Church Refurbishment Update

26/6/23

Revised overall floorplan

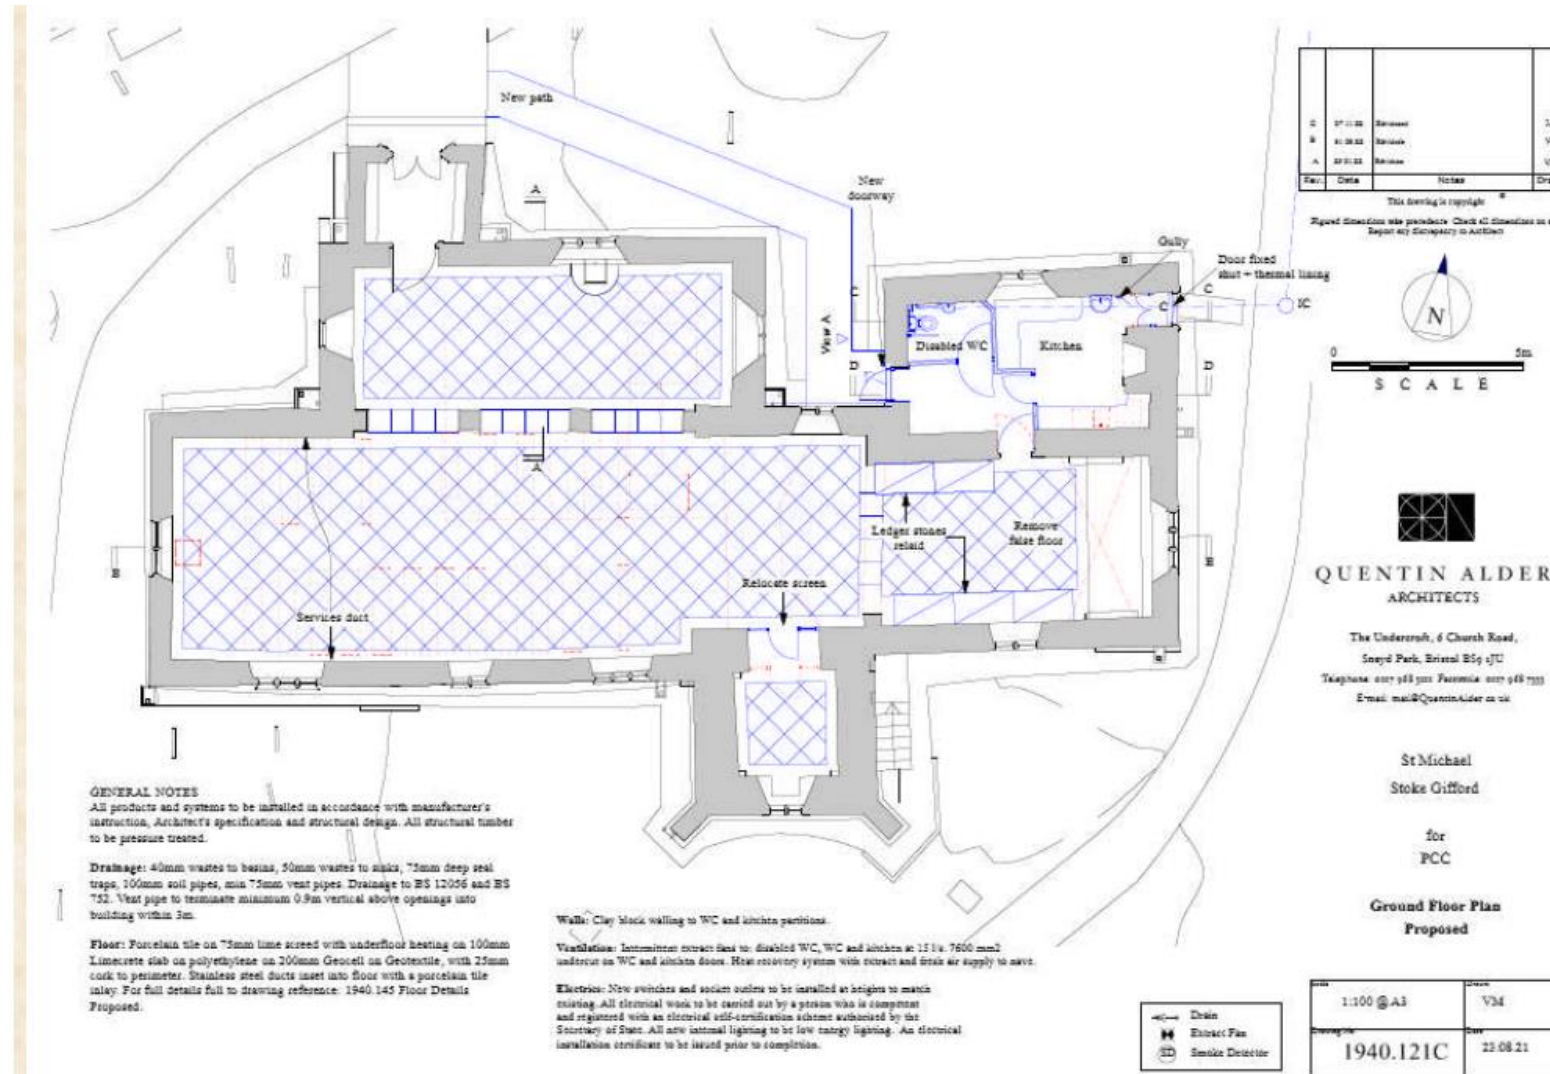
- Pillars will no longer be removed due to historical significance
- Only one accessible toilet will be built in what is currently the vestry
- A mechanical air handling unit will be installed in the ceiling void in the nave. This improves the ventilation of the building and the efficiency of the heating system.
- The door to the current vestry will remain as it is, i.e. it won't be moved
